Project No.: **16M124-2**

Subject: **Geotechnical Report Update and Plan Review**
Building E
SWC of Oleander Avenue and Decker Road
Riverside County, California

Subject: **Change of Engineer of Record, Response Report and Plan Review**
Building E
SWC of Oleander Avenue and Decker Road
Riverside County, California

2) Review Comments, Riverside County Planning Department, County Geologic Report No. 2492.

UPDATED GEOTECHNICAL MAP
BUILDING E
RIVERSIDE COUNTY, CALIFORNIA

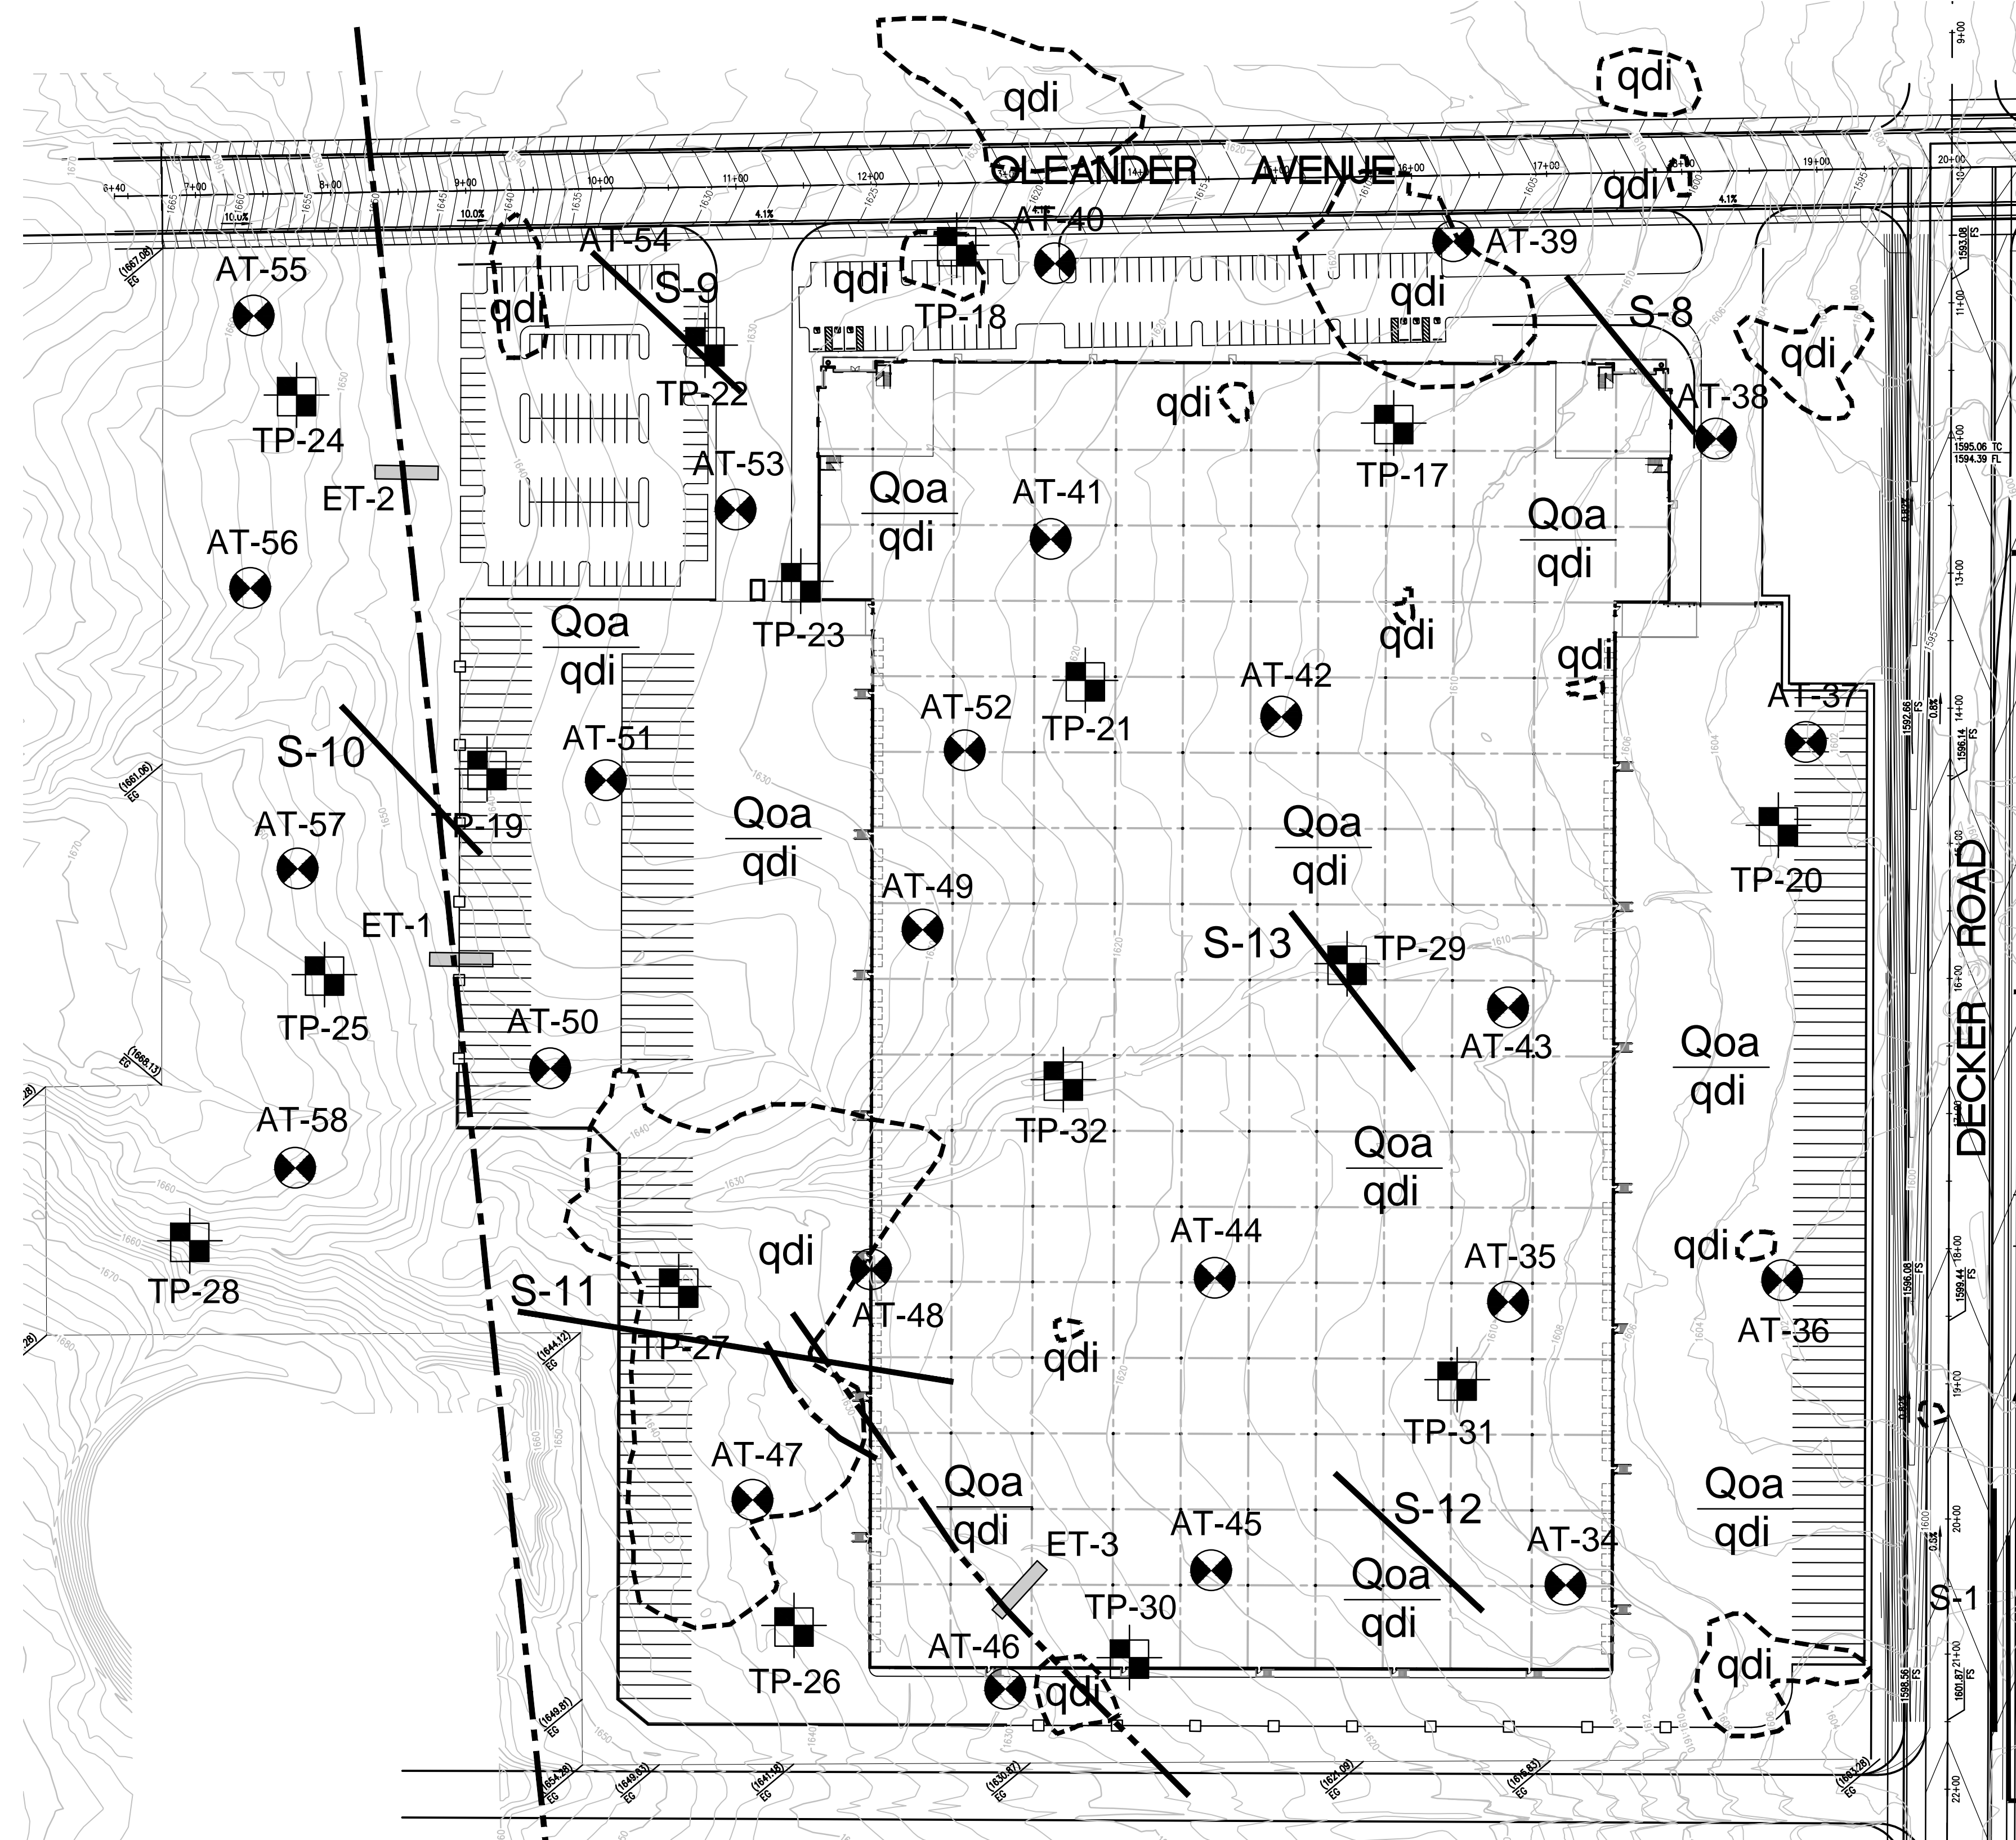
- RPD 6: *The report copy provided to the County fo review did not include a Geotechnical Map (Plate 1). Please Provide.*
- SCG: A Geotechnical Map is included with this report as Plate 2.

5. Please provide a listing of significant seismic events in the site vicinity (100 km).
6. The report copy provided to the County for review did not include a Geotechnical Map (Plate 1). Please provide.
